Genesis Fashions Ltd. (Extension-2)

Madhokala, Sreepur, Gazipur 1740

21 April 2025

2. Observation:

Observation-06: Load Plan Post and Implementation. (Annex Building)

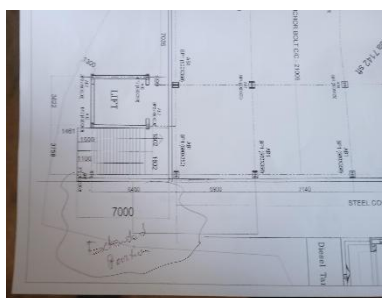
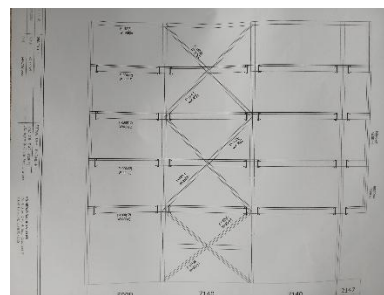
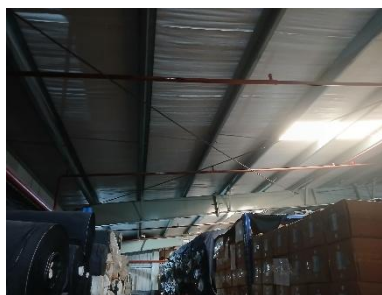
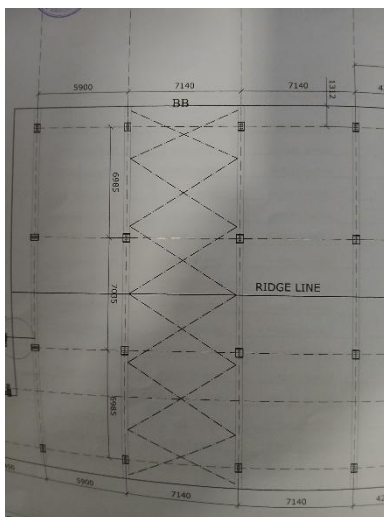
Description: Load plan not posted, load restriction height marking not found on the storage area. Building engineer is required to implement floor load management program, including posting load plan, height marking on the storage area.

8.		Carry out the suggested remedial works if required.	within 6 months
9.	Load Plan Post and Implementation. (Annex Building)	Building engineer is required to implement floor load management program, including posting load plan, height markings on the storage area.	within 6 weeks
